From: Katie Jones [kjones@riceswd.com]
Sent: Monday, April 11, 2011 11:16 AM
To: Hansen, Edward J., EMNRD
Cc: Hack Conder; Hall, Sharon
Subject: BD H-19 vent (1R426-09) CAP Addendum
Attachments: BD H-19 vent (1R426-09) Additional Delineation - Figure 4.jpg; BD H-19 vent (1R426-09) Proposed Liner - Figure 5.jpg; BD H-19 vent (1R426-09) SB-9 and SB-10 Logs.pdf; BD H-19 vent LAB 3.23.11.pdf; BD H-19 vent (1R426-09) CAP 1.5.11.pdf

This email is an Addendum to the BD H-19 vent site (1R426-09) Corrective Action Plan (CAP), submitted to the NMOCD on January 5, 2011. Page 3, section: Proposed Soil Remediation, paragraphs 1 and 2: text in blue lettering, below, will be added to the paragraph. Red lettering marked with a strike-through will be deleted. A plat showing the additional delineation (Figure 4), a plat showing the proposed liner in relation to the surrounding area (Figure 5), an aerial photo of the H-19 vent area, soil bore logs and laboratory results of the additional delineation, and the previously submitted CAP are attached. If you need any further information, please let me or Hack know.

BD H-19 vent

Case #: 1R426-09

Figure 5

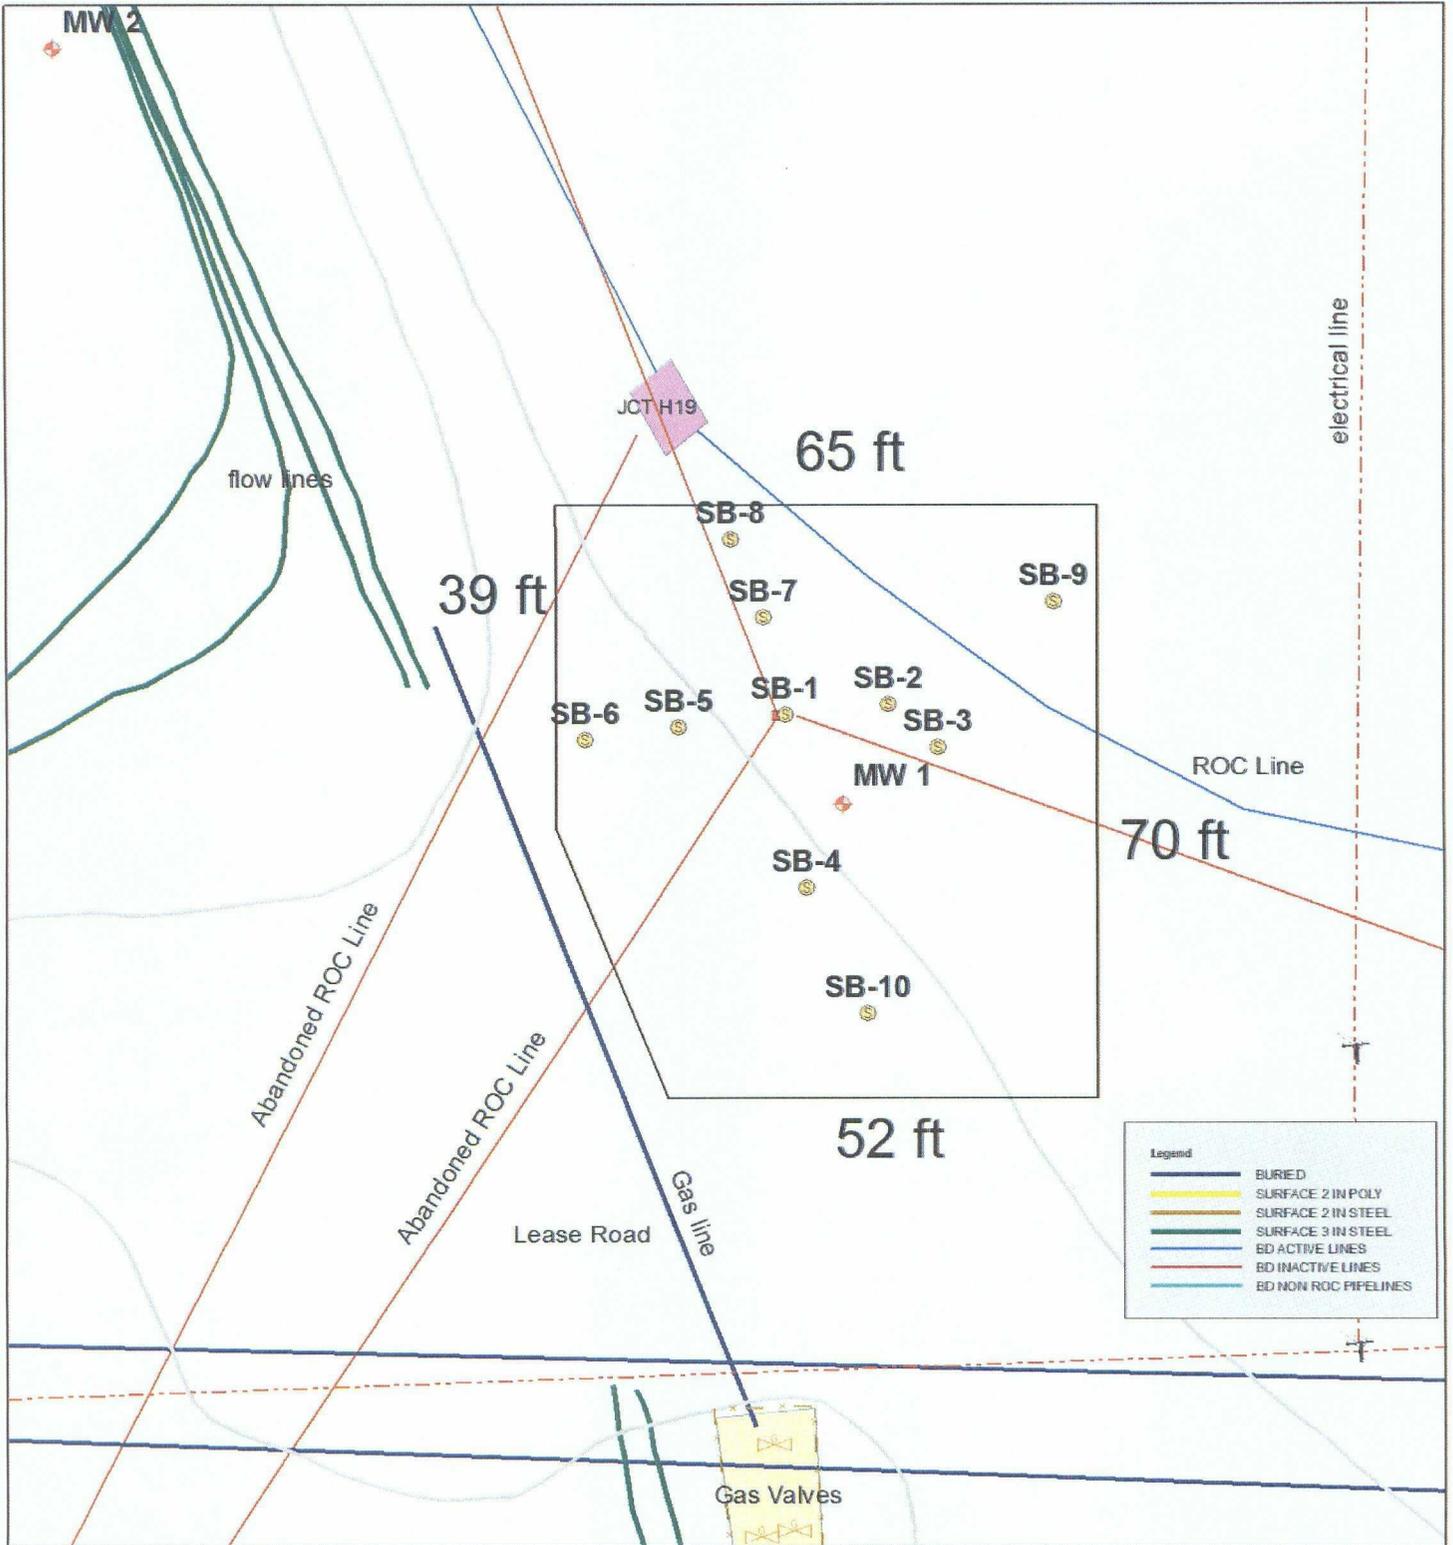
“With elevated chlorides and negligible levels of TPH, ROC proposes to excavate an area measuring ~~5065~~ feet by ~~5070~~ feet (avoiding the southwest corner to remain a safe distance to the nearby gas pipeline) by 4 to 5 feet deep and place a 20 mil polyethylene liner at 4 feet bgs in order to impede further vertical migration of the remaining chlorides within the soil. To verify these proposed liner dimensions, additional delineation was conducted on March 23, 2011. A soil bore was drilled 35 ft east of the former junction box (SB-9) and 37 ft south of the former junction box (SB-10). Field and laboratory results for the additional delineation are attached. The liner will extend from the initial junction box and cover all the soil borings. See attached Figures 4 and 5 for the proposed soil liner location and dimensions. Note the location of the proposed liner in relation to the active lines and lease road (figure 5). The site will be backfilled with soils containing a chloride concentration of less than 500 mg/kg and a PID reading of 100 parts per million (ppm) or less. Excavated soil will be evaluated for use as backfill and any soil requiring disposal will be properly disposed of at a NMOCD approved facility. Upon completion of the liner and backfilling, ROC proposes to revegetate the site with native grasses.
